DEVELOPMENT
APPLICATION

DRAWING REGISTER

OUR LADY OF THE ROSARY
CATHOLIC SCHOOL
The Entrance

PROJECT NAME :
**OUR LADY OF THE ROSARY
CATHOLIC SCHOOL**

DRAWING TITLE :
GA FLOOR PLANS
PROPOSED BLOCK G & H LEVEL 1 FLOOR PLAN

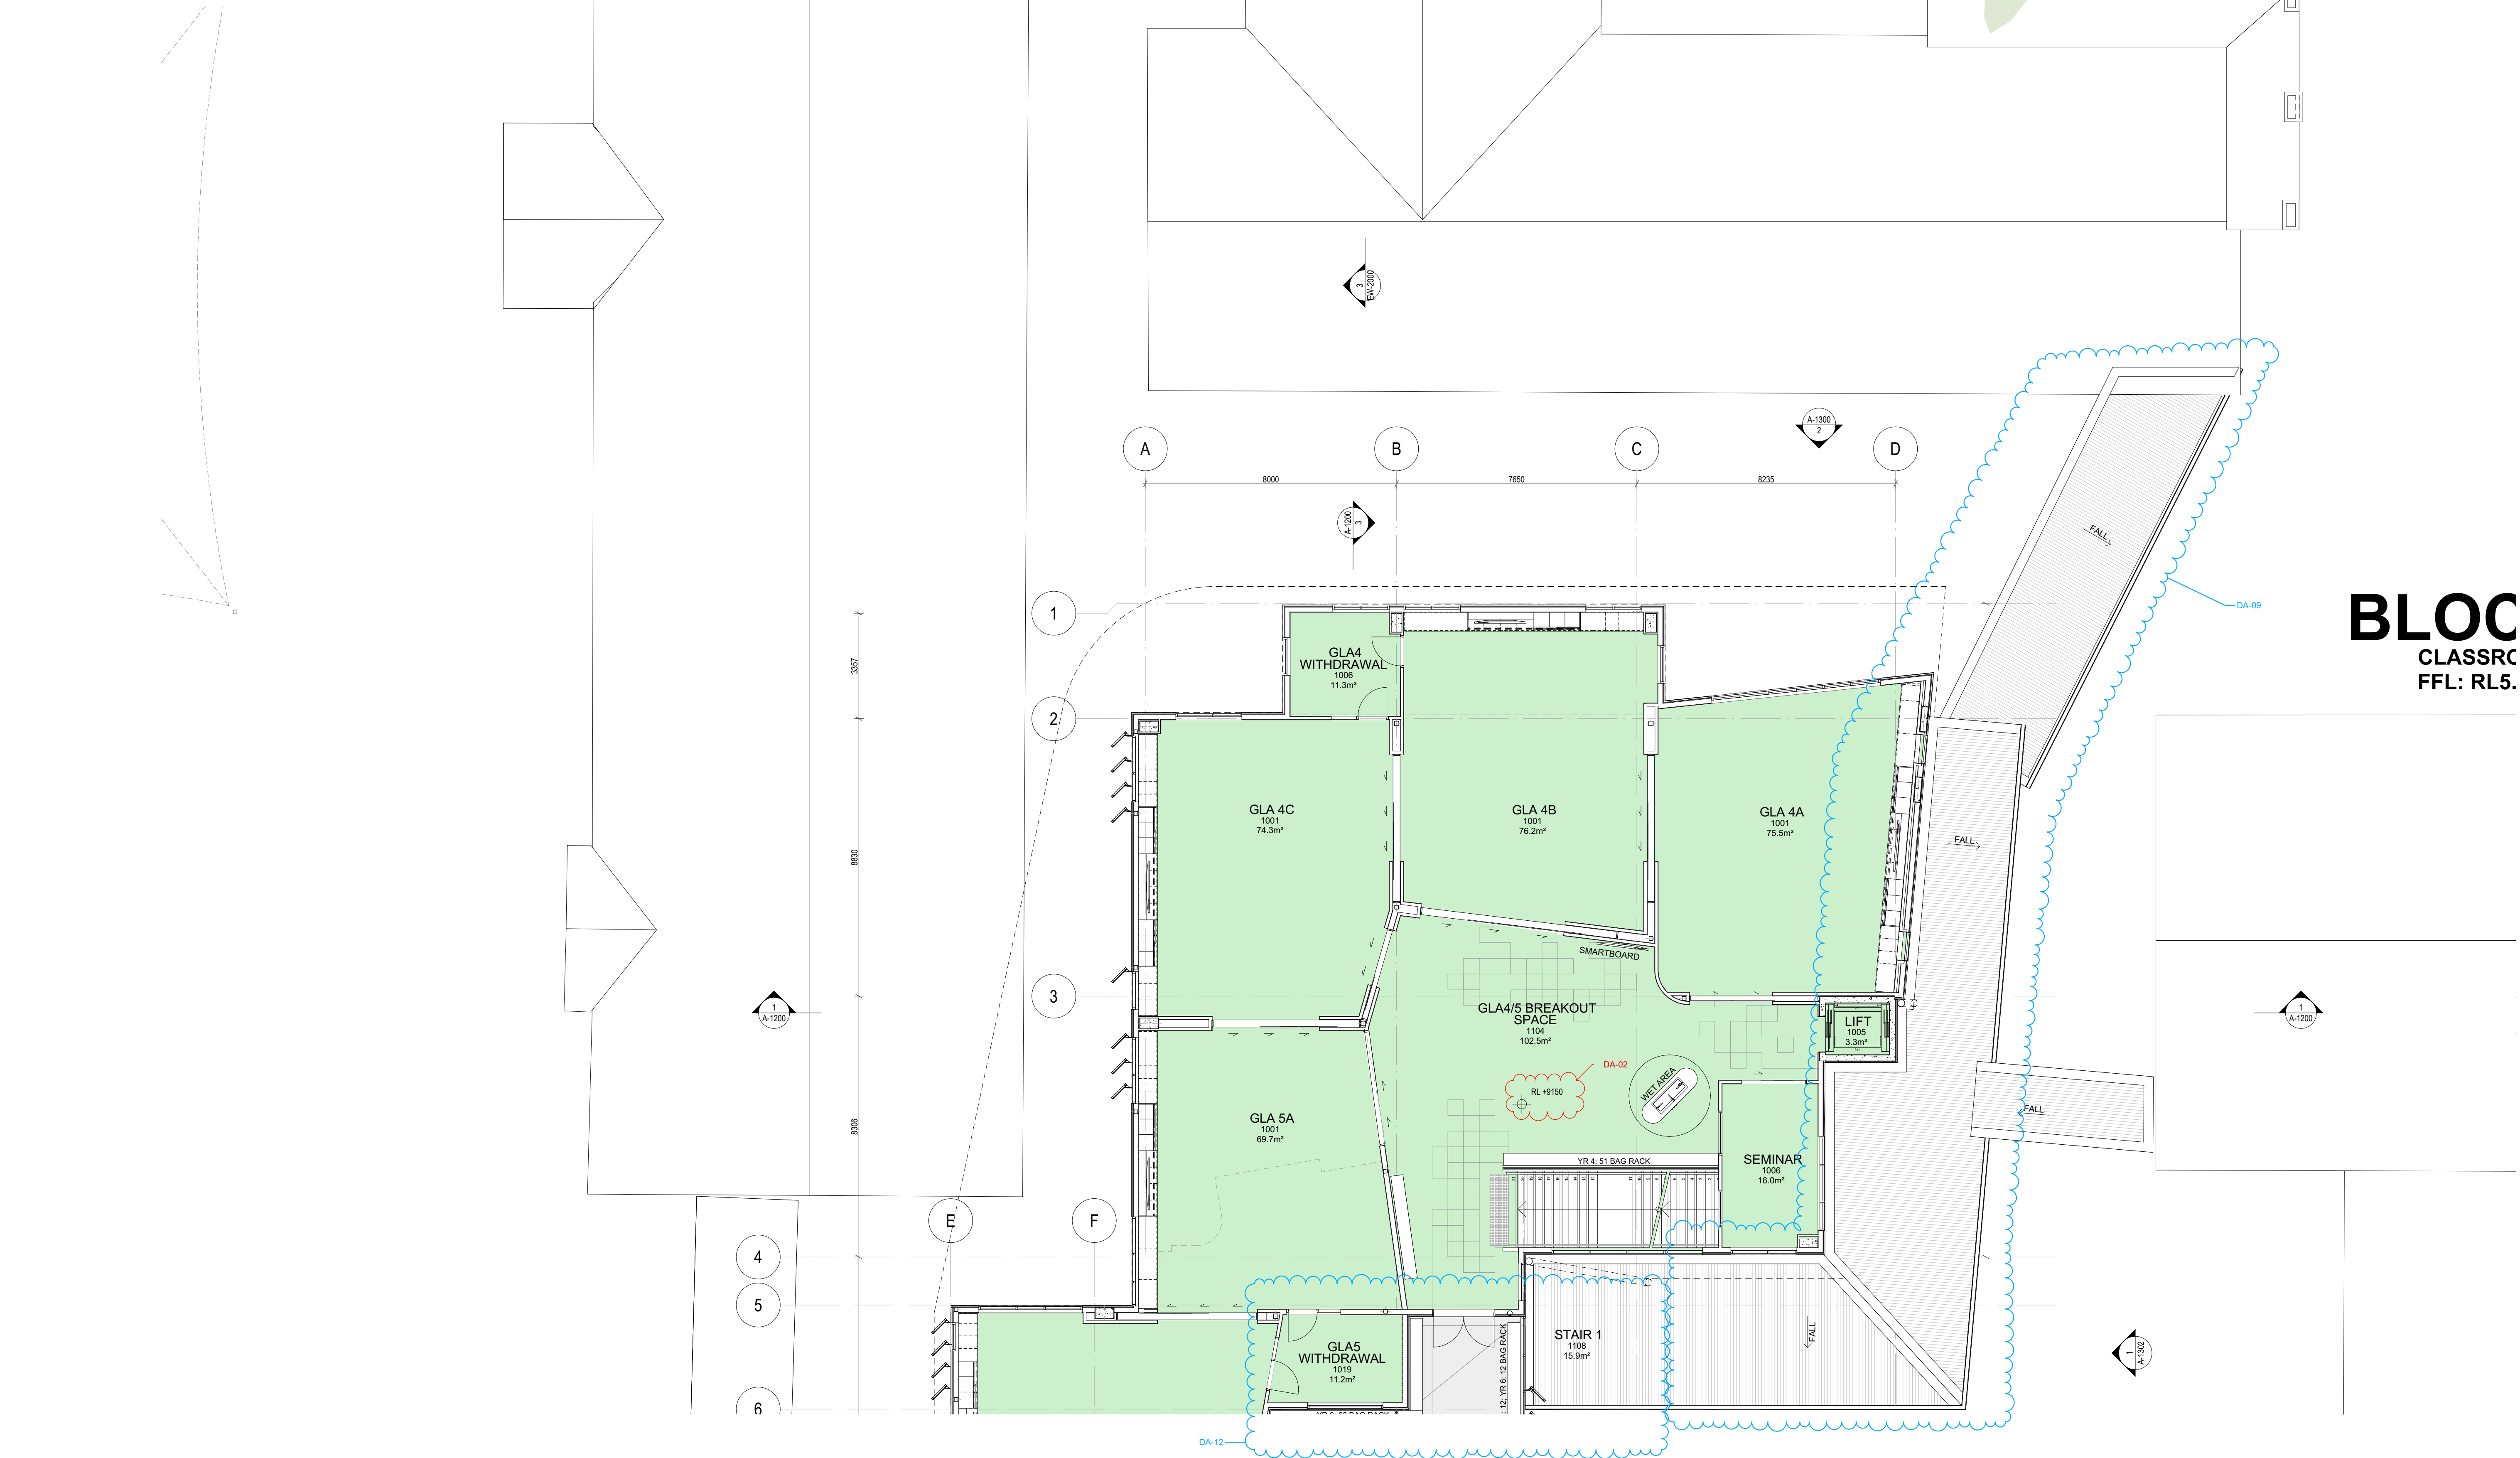
REVISION	DESCRIPTION	DATE
1	GLA'S RECONFIGURED AROUND EXTERNALISED SHARED SPACE	11/05/2023
2	ENTRY CANOPY REDUCED IN SIZE	11/05/2023
3	FFL RAISED TO SUIT FLOOD LEVEL	11/05/2023

SECTIONS

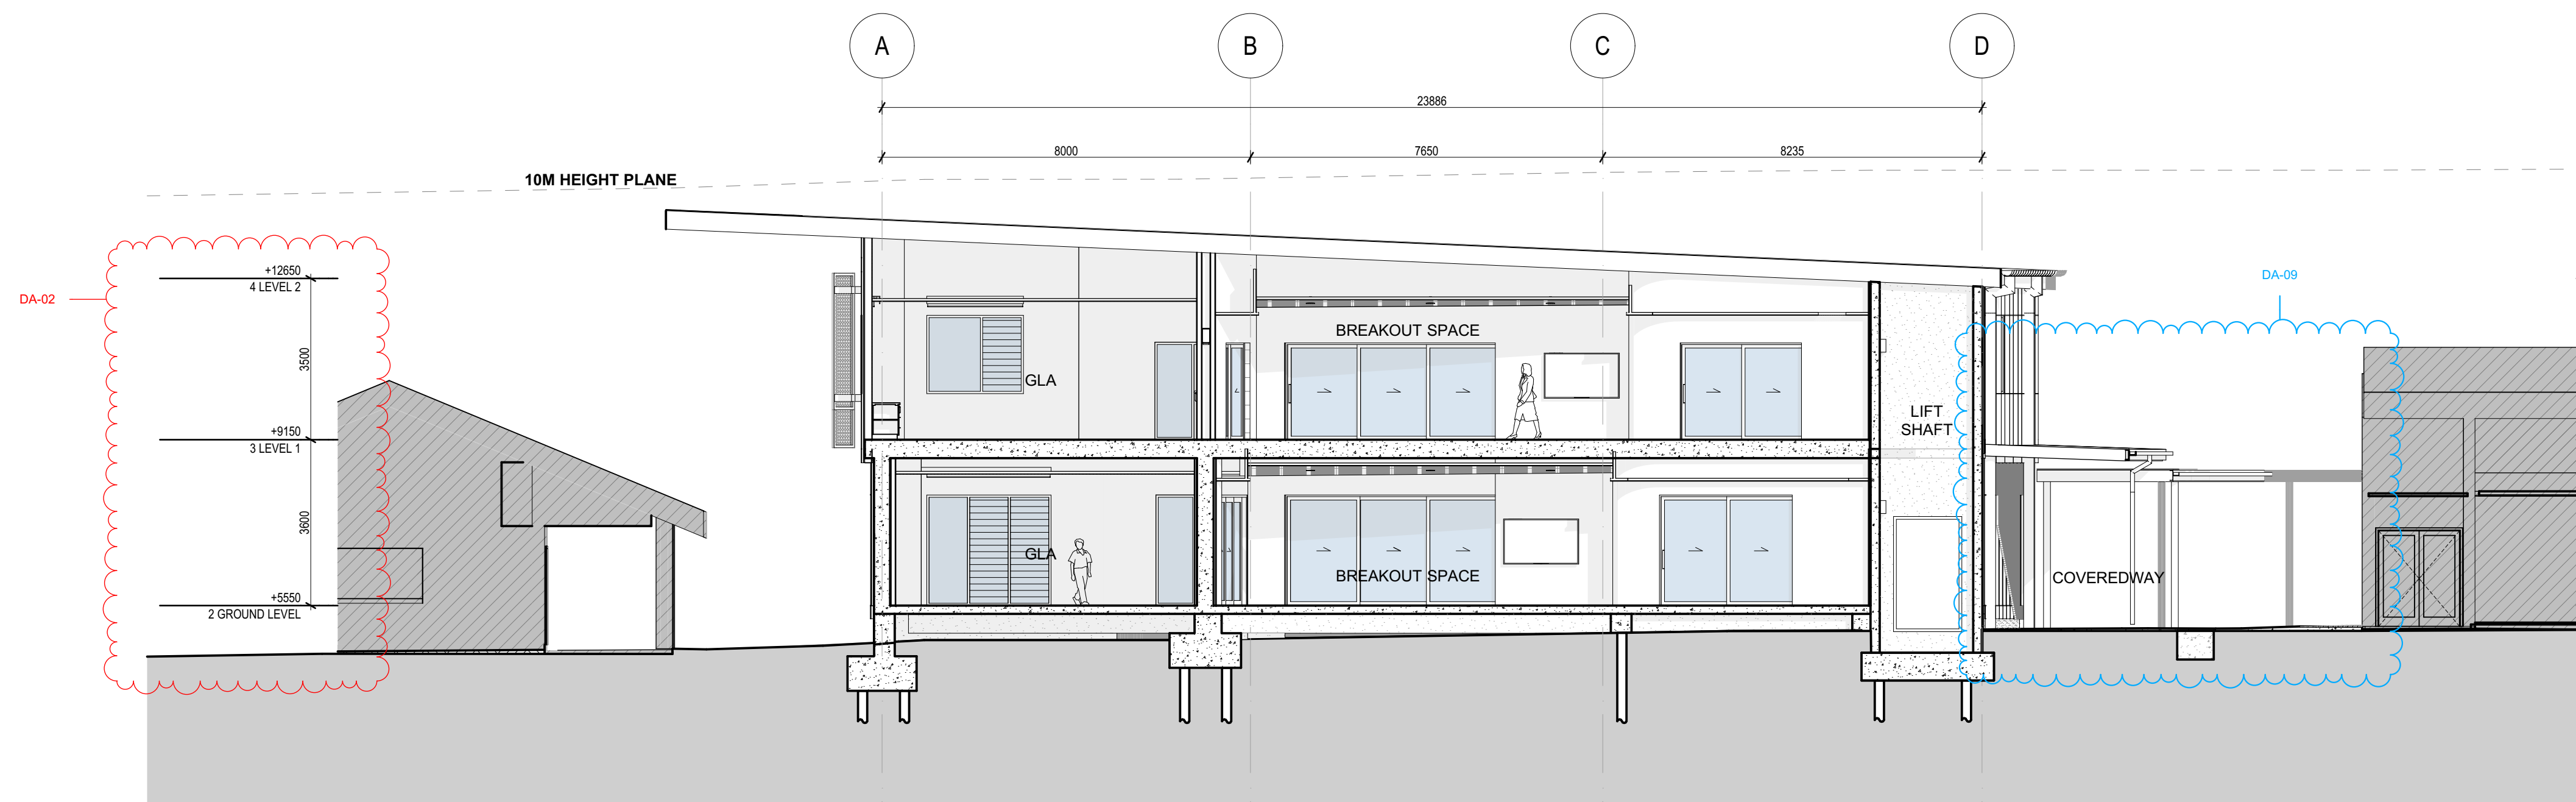
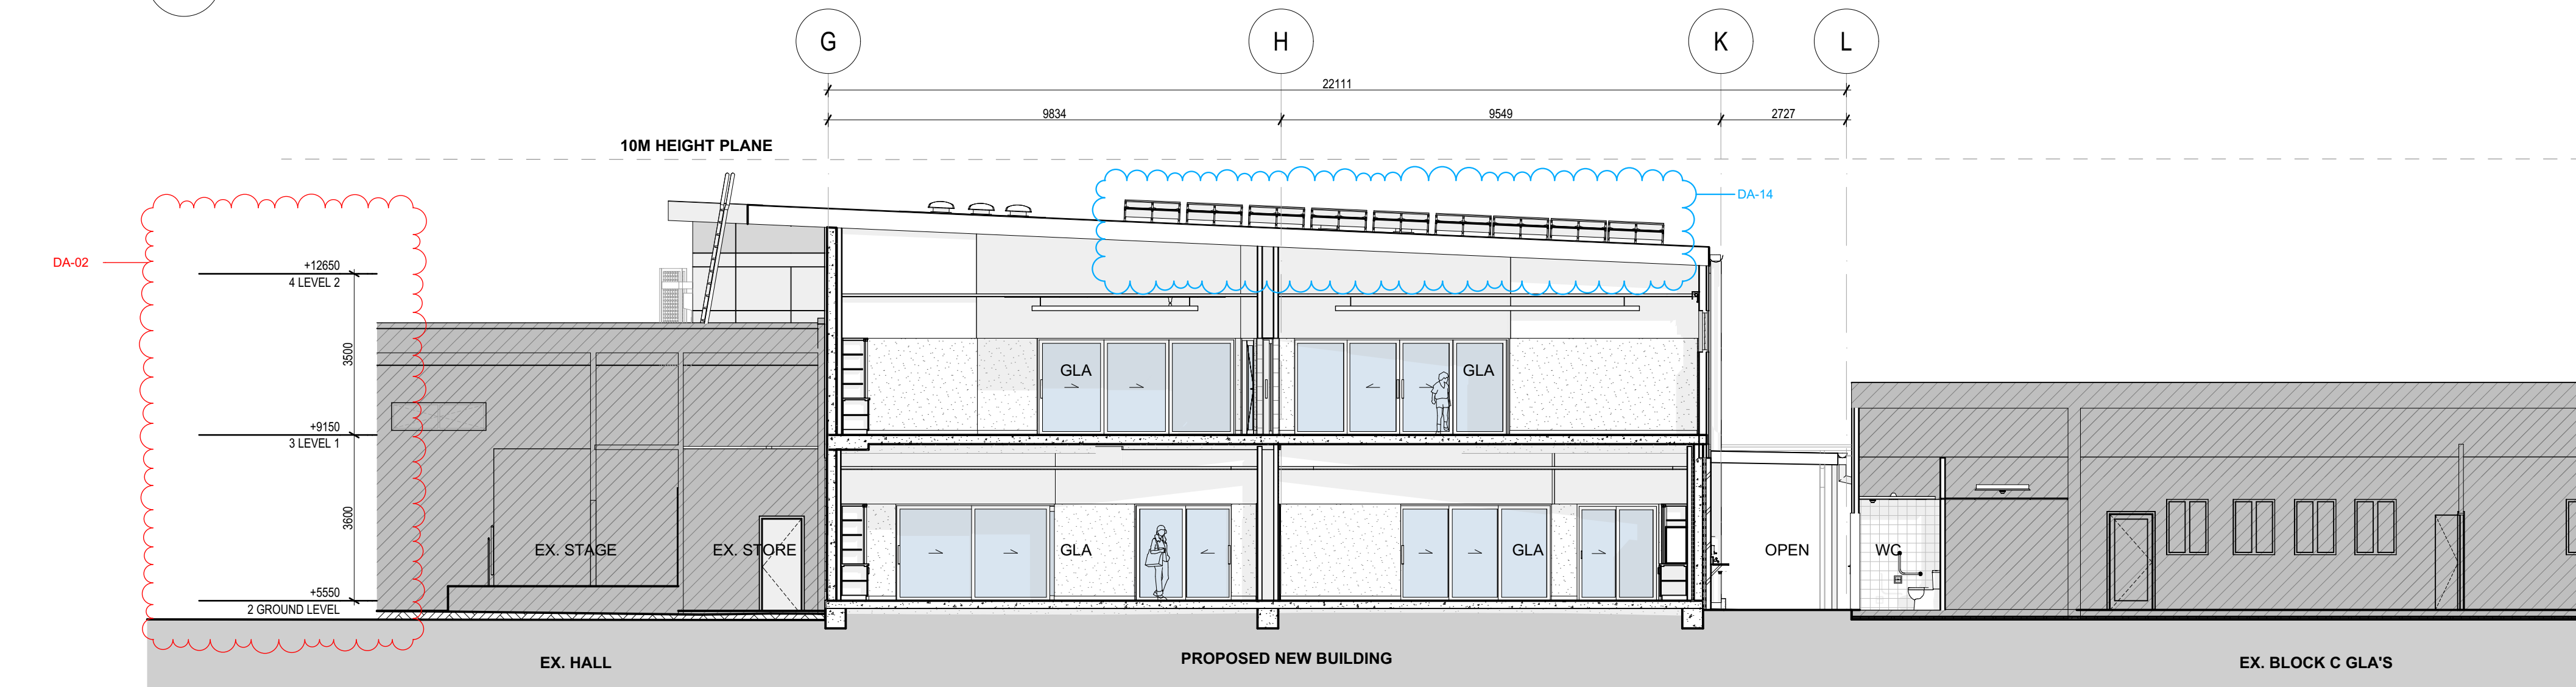
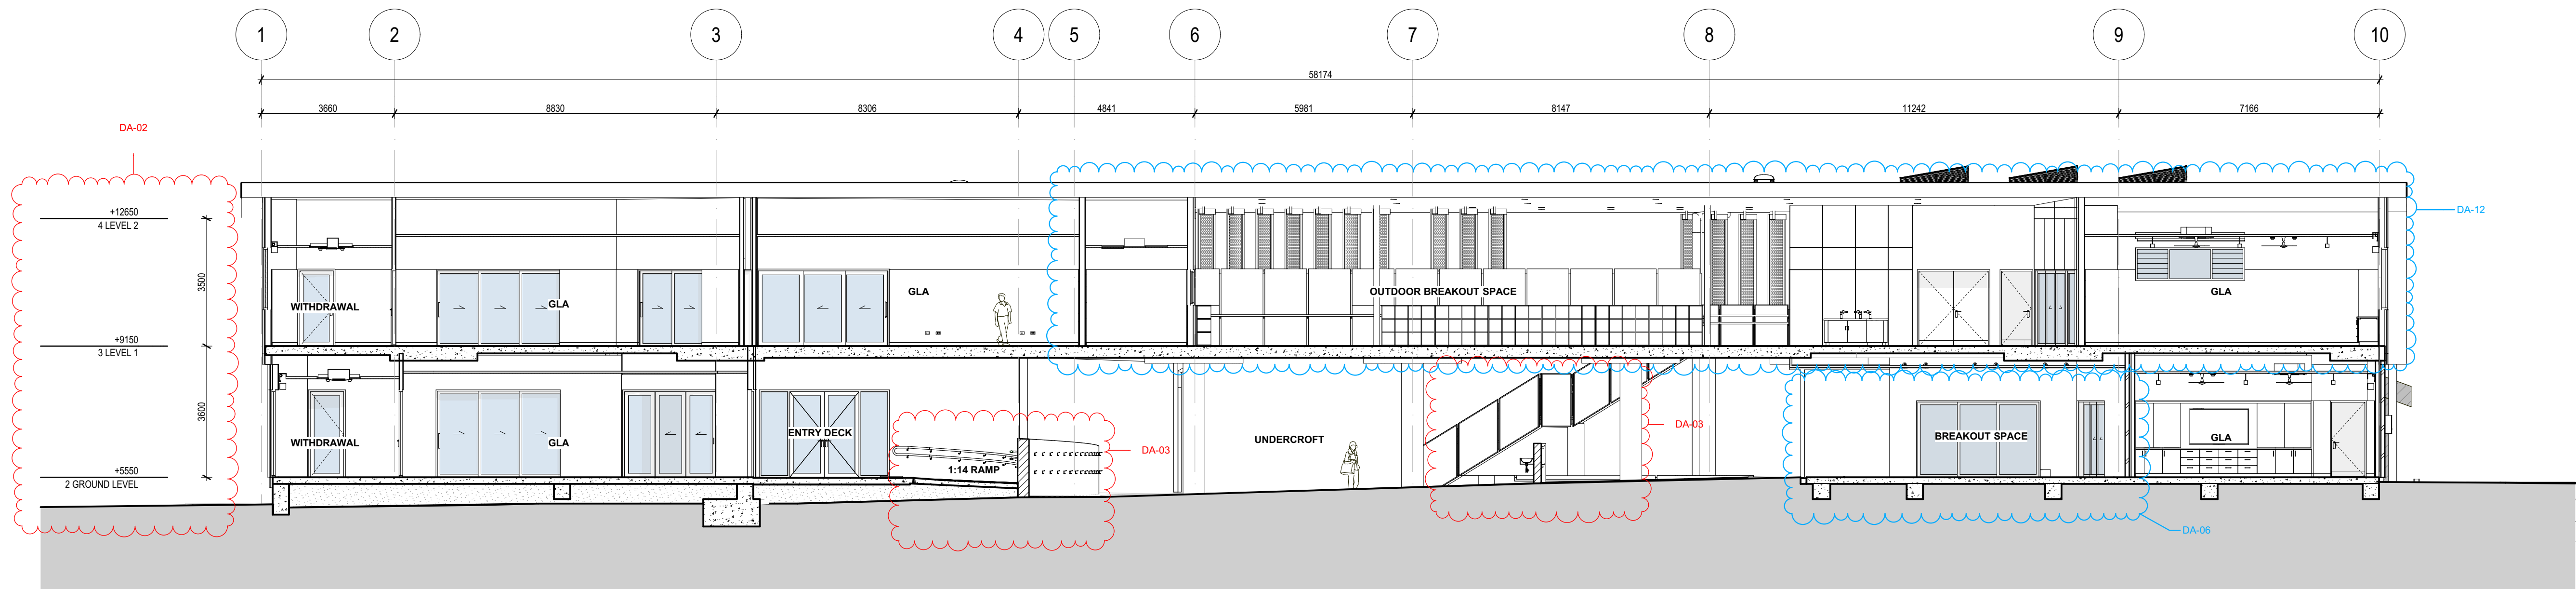
REVISION	DATE	DESCRIPTION
DA-14		SOLAR PANELS ADDED TO ROOF
DA-12		GLA'S RECONFIGURED AROUND EXTERNALISED SHARED SPACE
DA-09		ENTRY CANOPY REDUCED IN SIZE
DA-08		GLA'S SHARED SPACE EXTERNALISED
DA-03		STAIRS AND RAMP ADJUSTED TO SUIT NEW FFL
DA-02		FFL RAISED TO SUIT FLOOD LEVEL
